GENERAL NOTES A-2 - A-8
FLOOR PLANS

RENOVATION COMPANY TEXAS
 BUILDING UTILITIES COMPANY TEXAS
 MAIN WEST TEXAS ABILENE

RENOVATION BUILDING WEST TEXAS UTILITIES COMPANY ABILENE, TEXAS

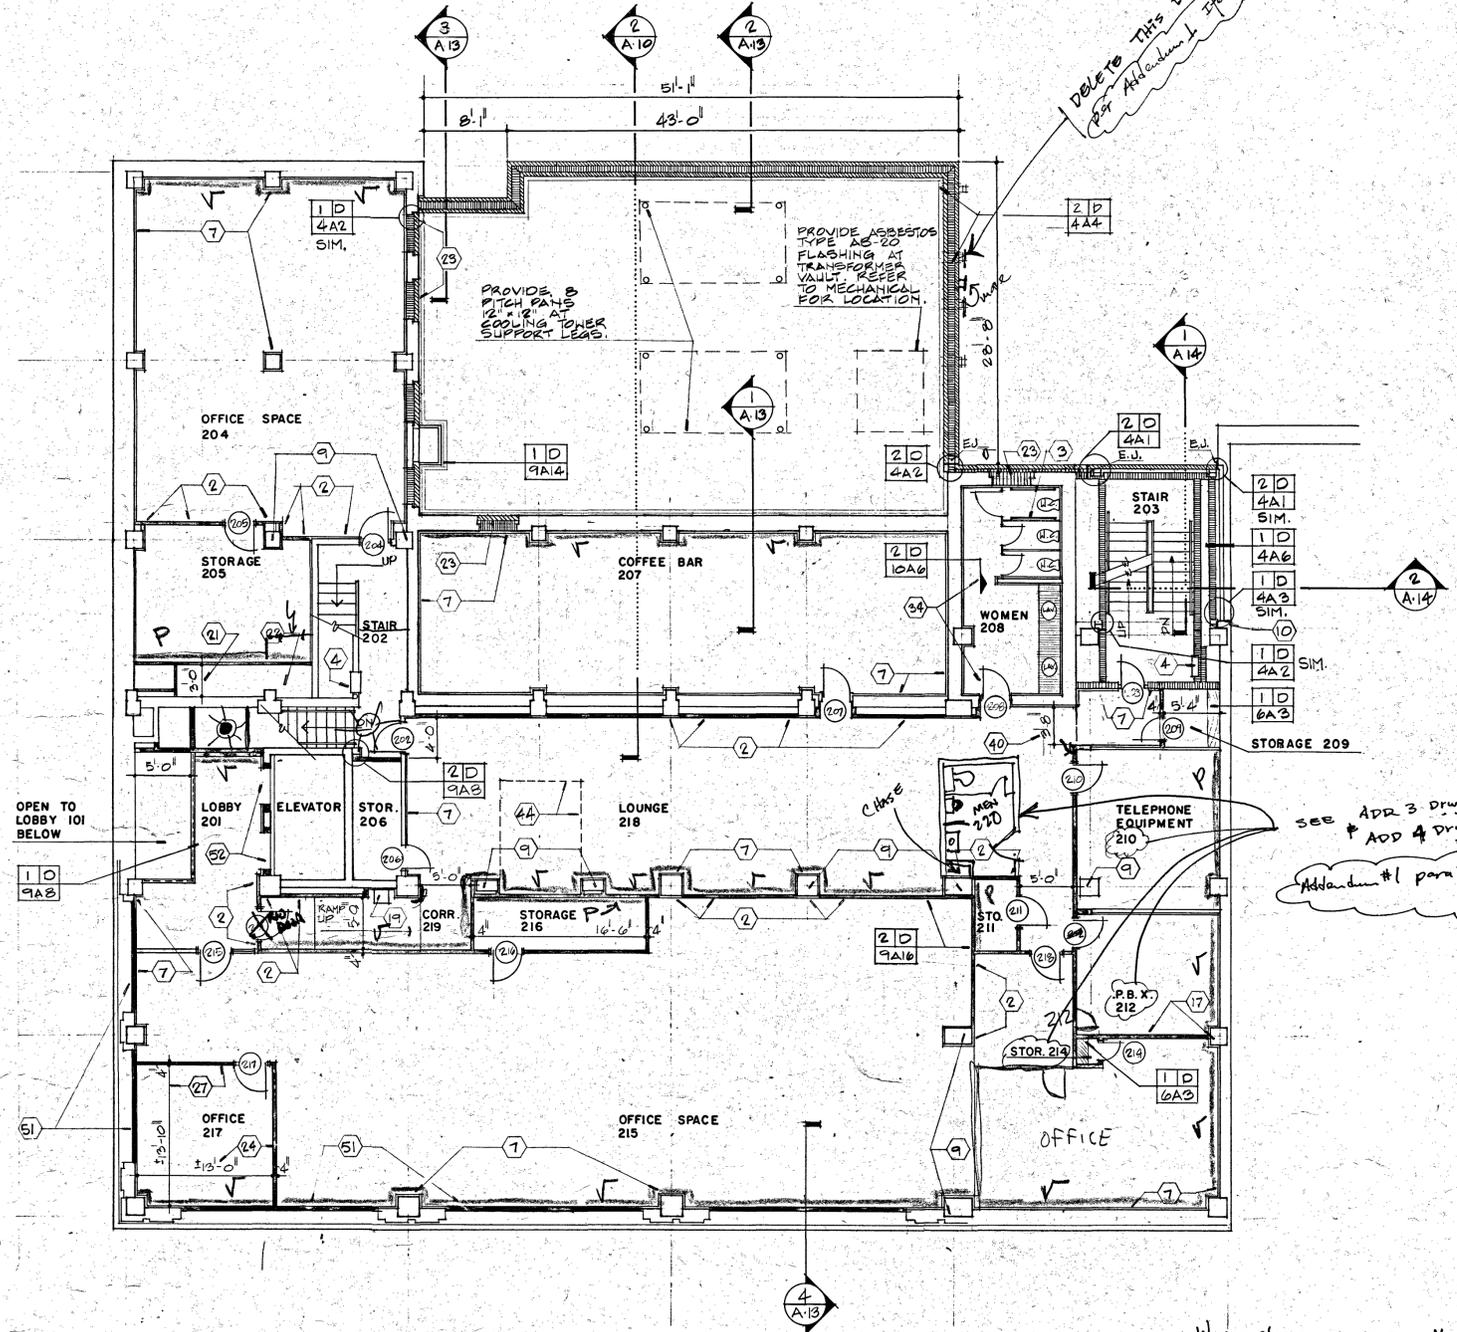
DELETE THIS DOWNSPOUT
Addendum #1 para 214
TRM.

FILL W/ MASONRY, & COVER W/ FURRING CHANNELS 16" O.C. # 1/2" GYP BOARD
Addendum #1 para 202

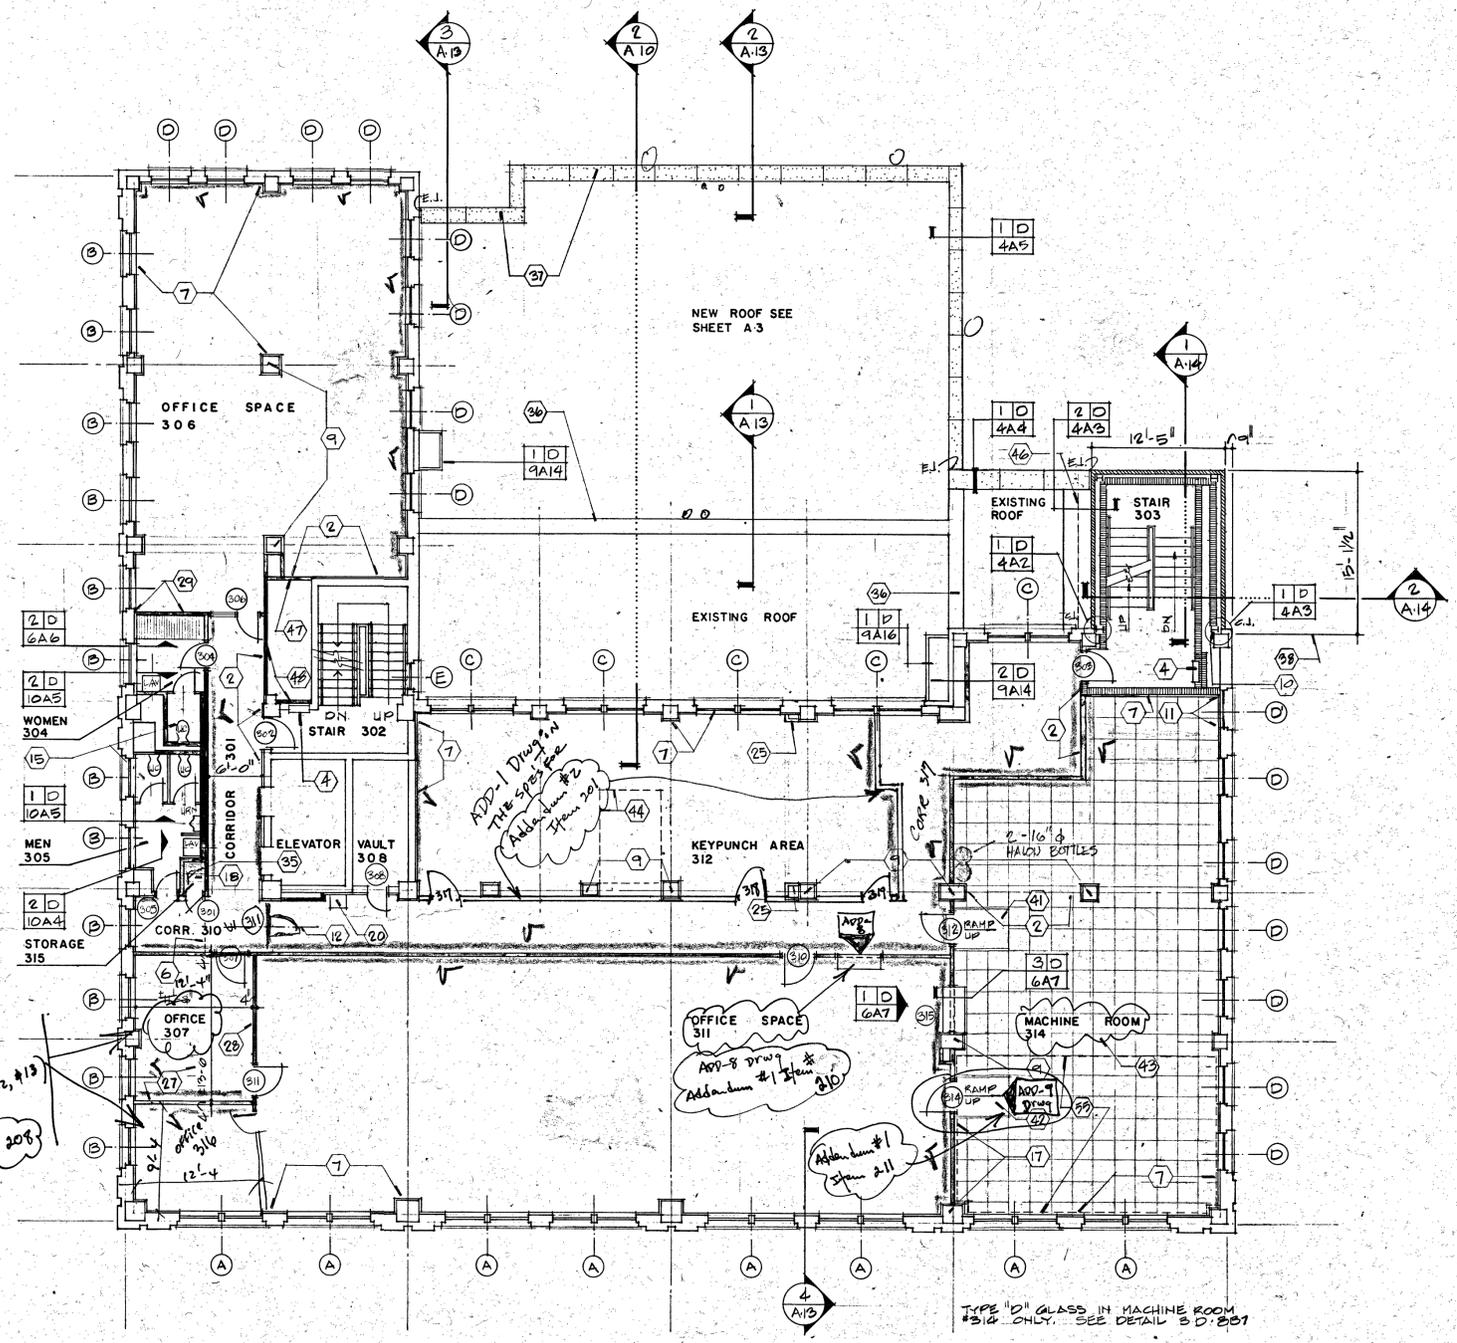
*Rework Room # 307
 & ADD Room # 316
 (See ADD sheets 10, 11, 12, 13)
 Addendum #1 Item 208*

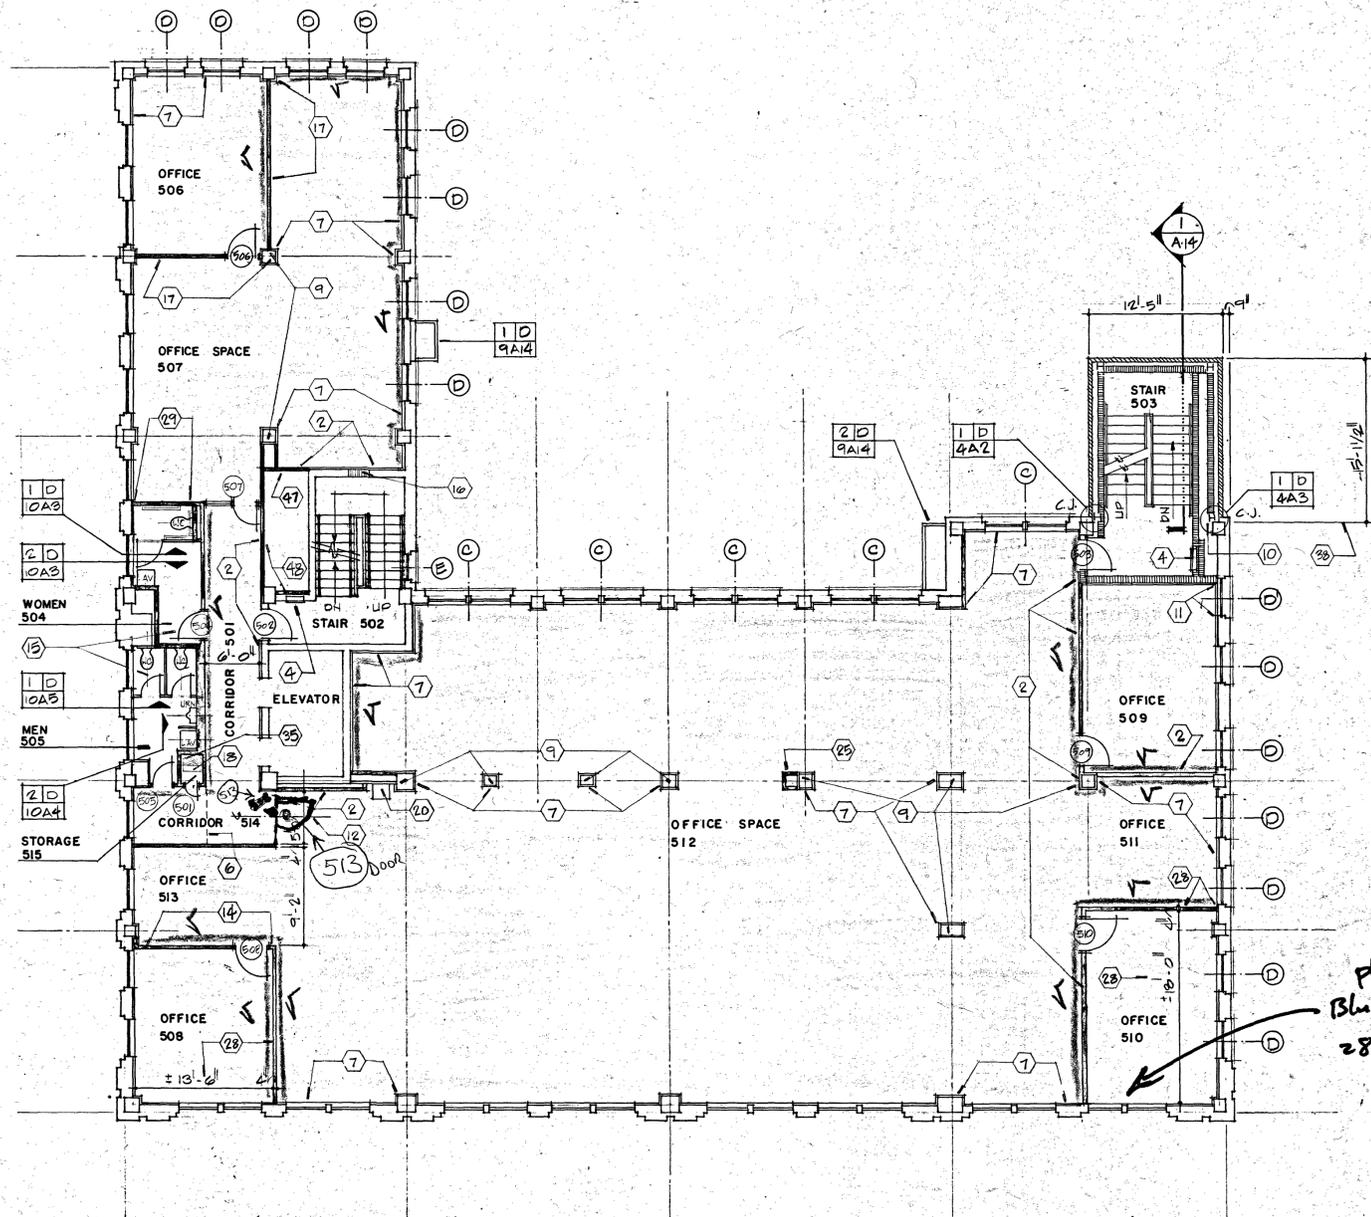
Water Closets to be floor mounted per Addendum #1 Item 213
